Environmental Minor Project Refinement Form

Project Name: West of Devers Upgrade Project **Request Prepared By:** Sylvia Granados

Date Approval Required: 3/15/2021 **Variance Request No.:** 45

Southern California Edison
West of Devers Upgrade Project
Proposed Work Areas
MPR #45

FIGURE 1
Page 10 of 10

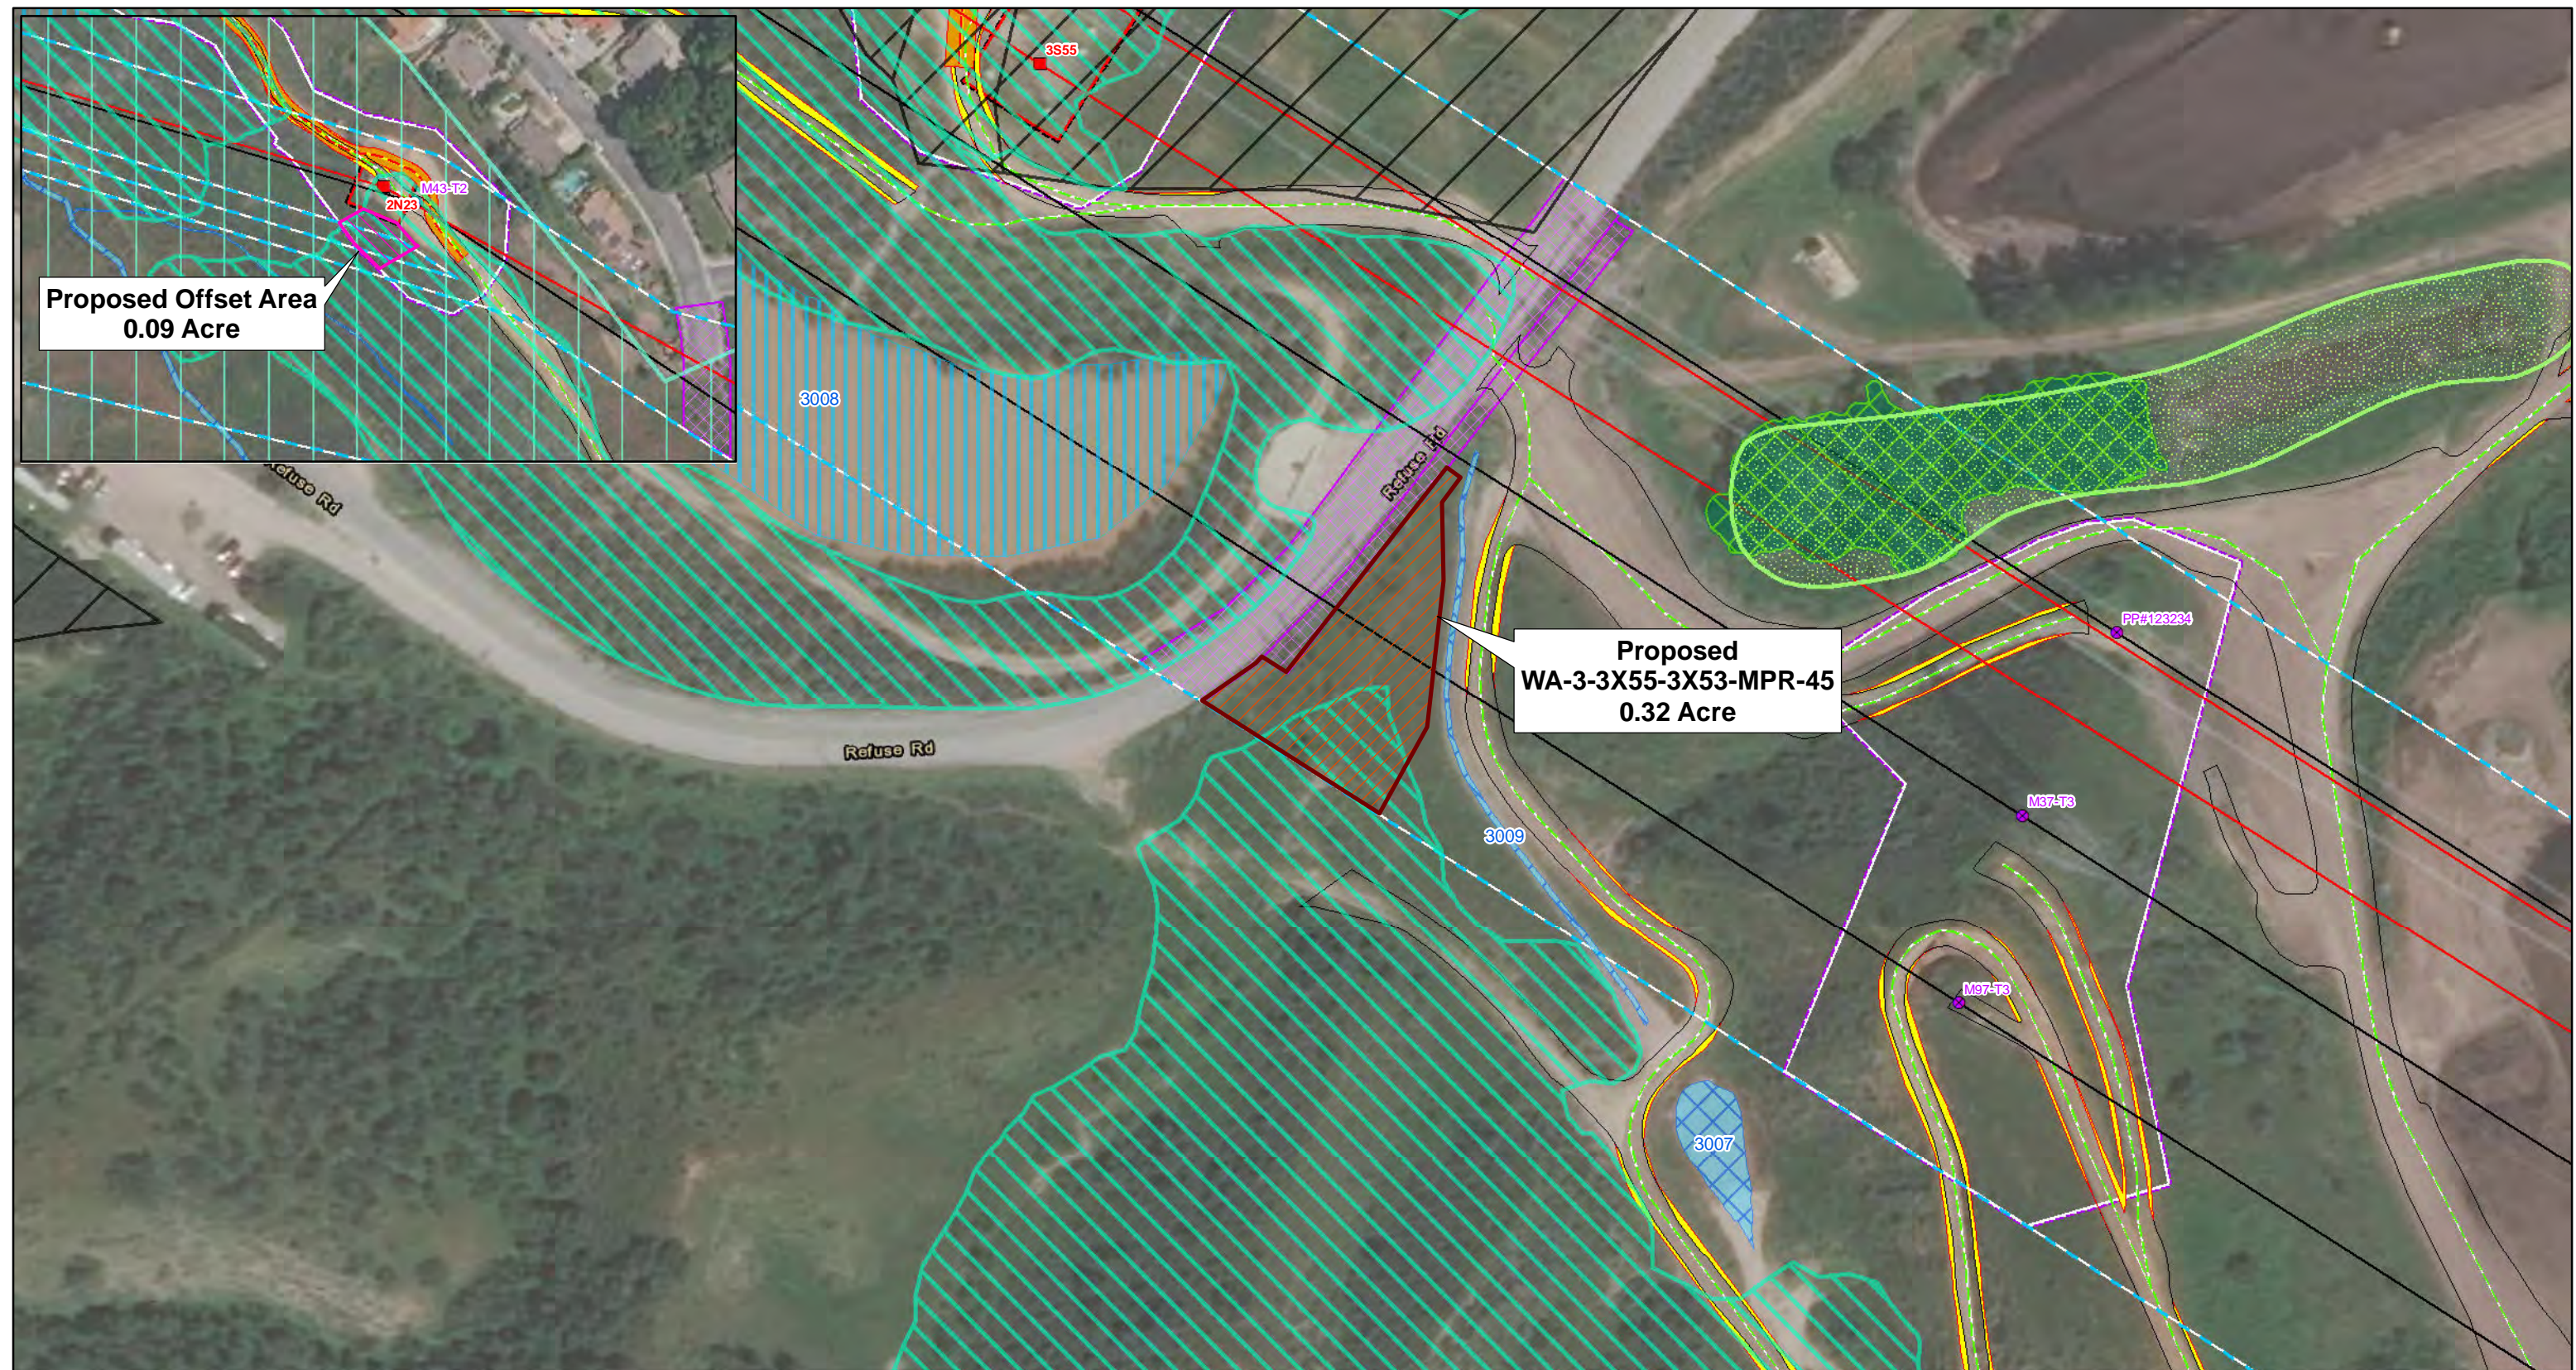
WA-3-3X55-3X53-MPR-45- Figure 1, page 10: Guard Structure Wreck-out

A new 0.32-acre temporary work area is required on the east side of Refuse Road to safely facilitate wire and guard structure wreck-out activities associated with M97-T3, as shown on Figure 1, Page 10. The new work area will be lightly graded to level the existing terrain.

Guard structure wreck-out work area GS-4-4X14-1-MPR-45 intersects Coastal CAGN Suitable Habitat, as shown on Figure 1, page 10. In the history (2014-2018) of protocol surveys conducted for the project in this area, there have been no detection of CAGN. Results were also negative during subsequent preconstruction surveys. However, to offset tempory

impacts to the mapped suitable habitat, an equal area of Coastal CAGN Suitable Habitat, shown in the detail on page 10, will not be used by construction, and will be removed from the project data upon approval of this MPR.
